DEVELOPMENT APPLICATION ASSESSMENT REPORT

Application Number:	DA2024/1094
Responsible Officer:	Phil Lane
Land to be developed (Address):	Lot 317 DP 16362, 326 Whale Beach Road PALM BEACH NSW 2108
Proposed Development:	Demolition works and construction of a dwelling house including swimming pool
Zoning:	C4 Environmental Living
Development Permissible:	Yes
Existing Use Rights:	No
Consent Authority:	Northern Beaches Council
Land and Environment Court Action:	No
Applicant:	Walter Barda Design Pty Ltd
Application Lodged:	14/08/2024
Integrated Development:	No
Designated Development:	No
State Reporting Category:	Residential - Single new detached dwelling
Notified:	21/08/2024 to 04/09/2024
Advertised:	Not Advertised
Submissions Received:	1
Clause 4.6 Variation:	Nil
Recommendation:	Approval
Estimated Cost of Works:	\$ 3,095,492.00

Figures 1 & 2 - Extract from consultants submission on behalf of the owner of 324 Whale Beach Road

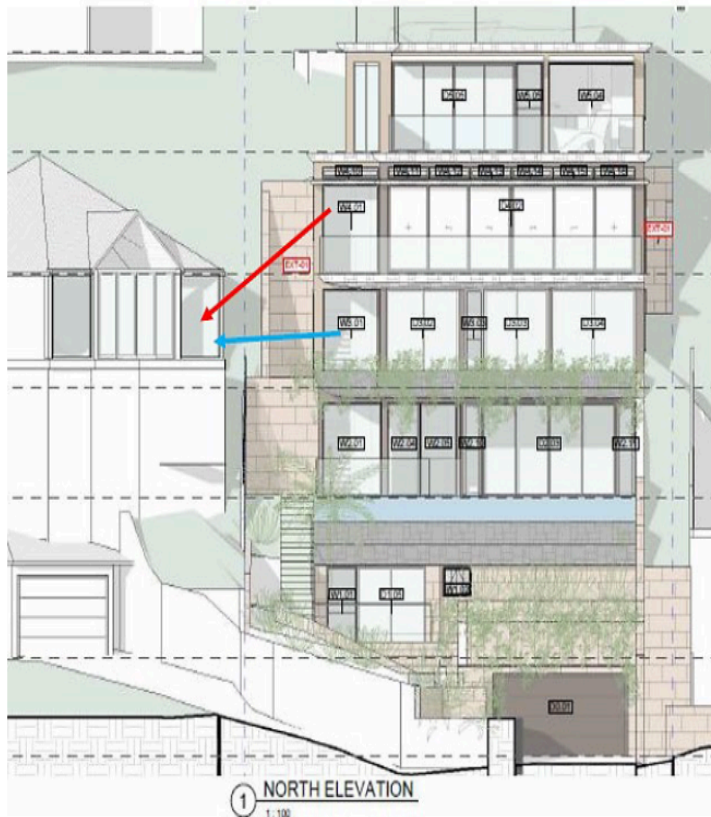
Privacy concerns were raised by the planning consultants acting on behalf of the owners of 324 Whale Beach Road. These concerns relate primarily to potential overlooking from the Level 1 and Level 2 balconies of the proposed dwelling at 326 Whale Beach Road into the habitable rooms and balcony of their property. It is noted that the existing dwelling and garage at 324 Whale Beach Road are oriented to the north-east, positioning the primary outlook of the residence towards the shared side boundary with 326 Whale Beach Road. This orientation increases the sensitivity of any potential overlooking impacts from the proposed development and has been a key consideration in Council's assessment.

Figure 4: Composite elevations showing overlooking from the proposed level 1 and 2 balconies of 326 Whale Beach Road to the balcony of 324 Whale Beach Road.

(c) The southern wrap-around section of the Level 1 balcony will also be deleted, and the planter box relocated to this area as a privacy measure. This will also be secured via condition.

Figure 3: Area above 8.5m height plane highlighted in purple and calculation of slope under the building footprint

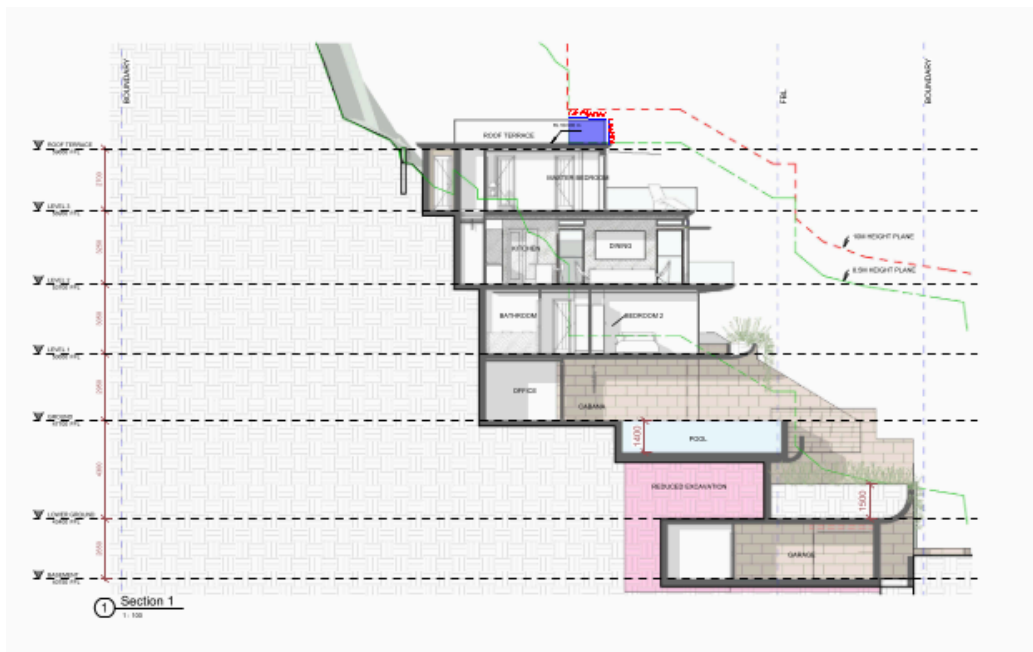
The areas of the dwelling house that protrude above the 8.5m height plane are confined to minor portions of the roof terrace within these portions of the dwelling. The breaches occur for a horizontal length of 1.6m for a vertical length of 1m on the roof terrace. Figure 3 (Section 1) below depicts the areas that protrude above the 8.5m height plane. These areas above the 8.5m height limit are considered minor given the low percentage (1.2%) these areas demonstrate overall versus the high percentage (98.8%) of the building demonstrates compliance with the 8.5m height control.

Figure 7: Location of proposed landscape stair and landing

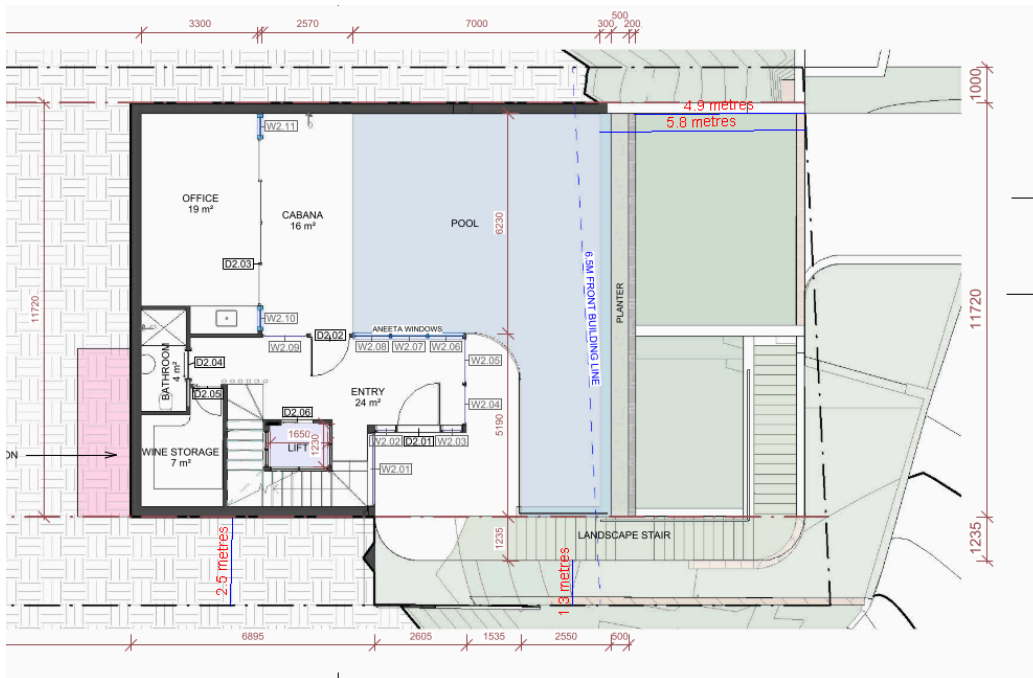
The proposal includes the addition of an external staircase and landing located adjacent the site's southern side boundary. This staircase and landing is provided external access from the front portion to the dwelling house.

The location of this staircase (1.3m from the southern side boundary) results in non-compliance (0.7m - 35% variation) with the control as it is not set back 2 meters from the side boundary.

Given the steep slope of the site, it is considered reasonable to provide an external staircase/landing to the dwelling to provide access between levels. As the function of staircases is to provide access between levels and are not typically used for long periods of standing this proposal is not considered to result in unreasonable amenity impacts.

Figure 9: Level 1 with only a 0.6m setback to the lightwell/retaining wall/drying terrace

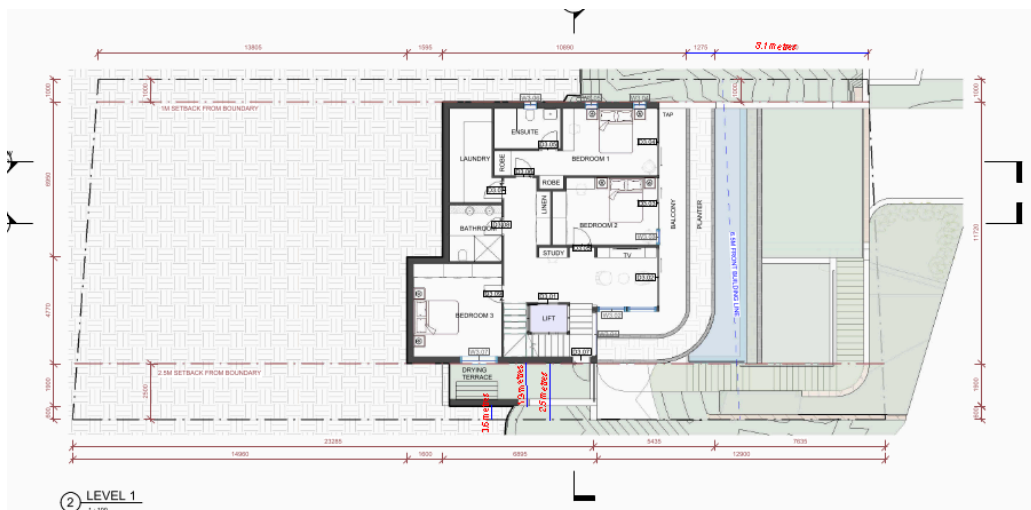
For the assessment of this application, the northern boundary is required to provide a 1m setback, while the southern boundary must provide a 2.5m setback. In this instance, the Level 3 balcony has a 2.2m setback, and the proposed lightwell retaining wall and drying terrace on Level 1 are set back only 0.6m from the southern side boundary. These setbacks represent non-compliances of 12% to 76%.

The current siting of both the Level 3 balcony and the Level 1 lightwell/retaining wall/terrace is not supported in their proposed form. Conditions will be included requiring the deletion of the southern portion of the Level 3 balcony to achieve compliance with the 2.5m setback. In addition, the lightwell retaining wall and drying terrace on Level 1 will be required to be set back a minimum of 1.5m from the southern boundary. This amendment would reduce the extent of non-compliance from 76% down to 40%, representing a substantially more supportable outcome.

- A minimum setback of 1.5m from the southern boundary for the retaining wall (noting the walls 0.3m width),
- This would result in a residual 0.7m clearance between the retaining wall and the southern boundary, providing sufficient space for light, ventilation, and maintenance access.

Figure 12 - Southern side boundary envelope

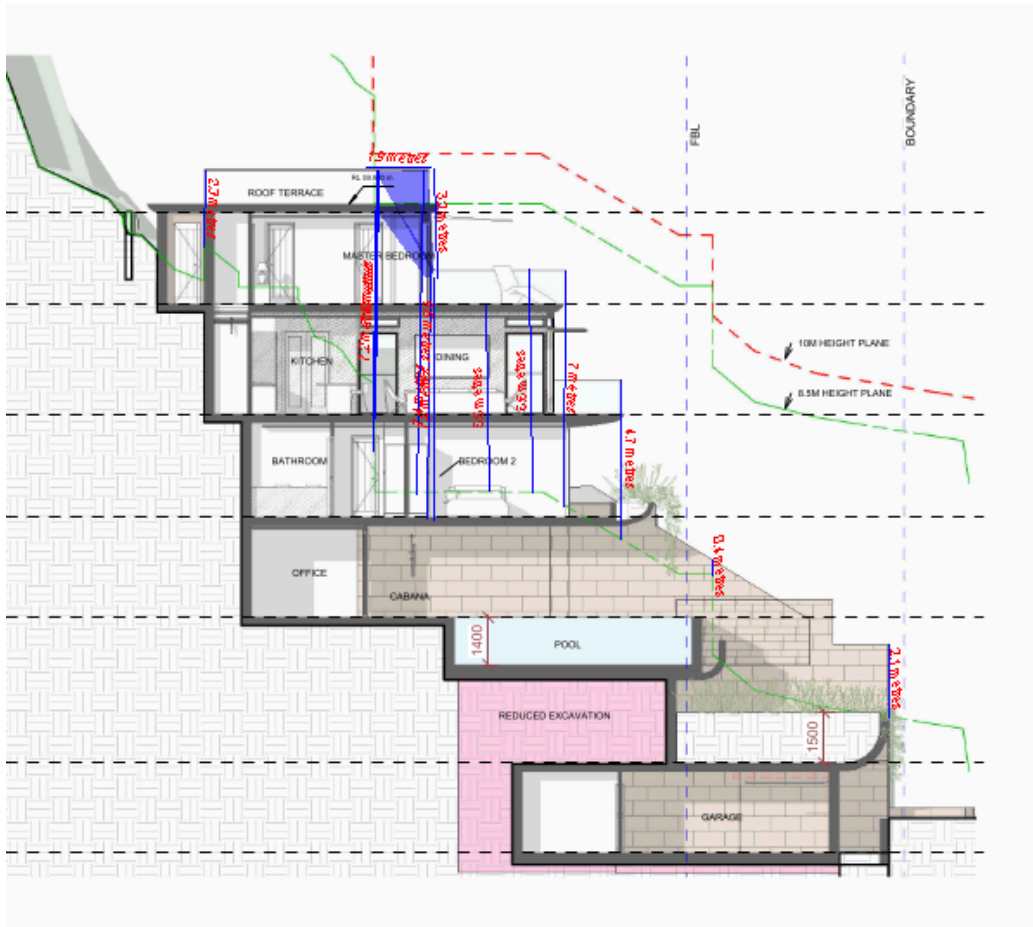
**Figure 11 - Envelopes demonstrating breaches of the envelope
(3D images supplied by the applicant's architect)**
